GROUP ELE	MODEL 2014MY Soul (PS)
	NUMBER 152	DATE September 2018
TECHNICAL SERVICE BULLETIN		
SUBJECT: MULTI-FUNCTION SWITCH REPLACEMENT FOR HEADLAMP FLICKERING

MULTI-FUNCTION SWITCH REPLACEMENT FOR HEADLAMP FLICKERING

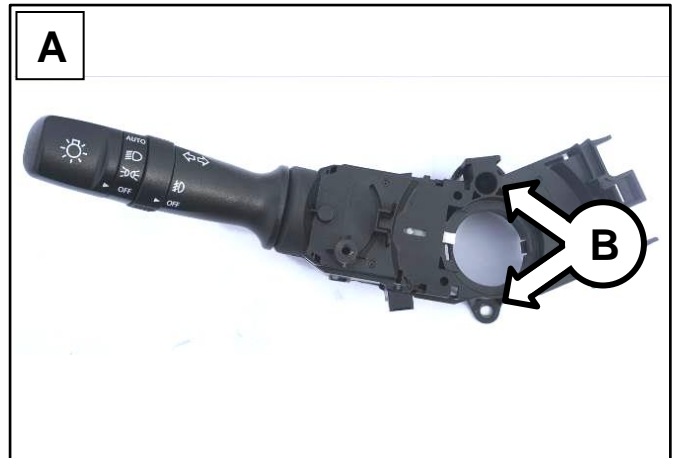
1. Replace the multi-function switch (A) by referring to the “Body Electrical Switch → Multifunction Switch → Repair procedures” chapter in the applicable Shop Manual on KGIS.

Be sure to replace the two (2) multi-function switch retaining screws (part no.: 12290 05121) (B) when installing the new switch (A).
